# Access Compliance Report

## Public Rights-of-Way

| Intersection ID: 45522                  | Main Street: LANSFORD_RD | Cross Street: WILBURN_CT                | Location:              | W                  |
| ADA ID: B4FDB69B5DA5                    | Ramp Type: Perp          | Initial Pass/Fail: Fail                 | Overall Compliance: No | Severity Score: 25 |

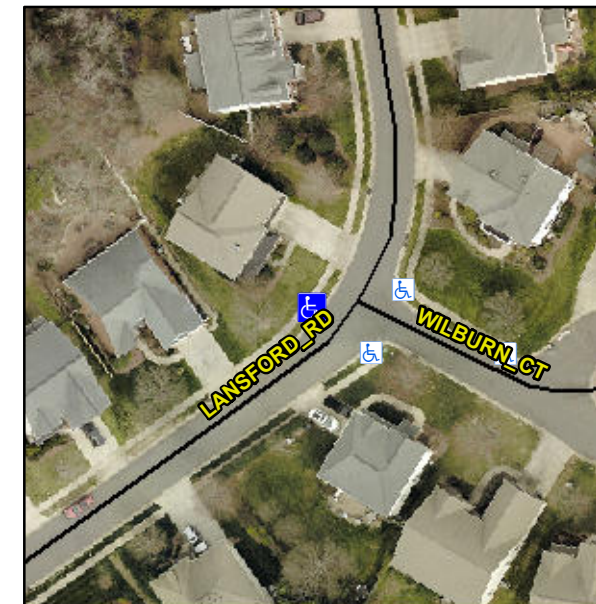
**R304.5.3**

| Compliance | Description           | Data  | Compliance | Description                 | Data |
|------------|-----------------------|-------|------------|-----------------------------|------|
| Yes        | Ramp Width (in)       | 48.0  | No         | Ramp XSlope (%)             | 7.0  |

**Remove & Replace Entire Ramp.**
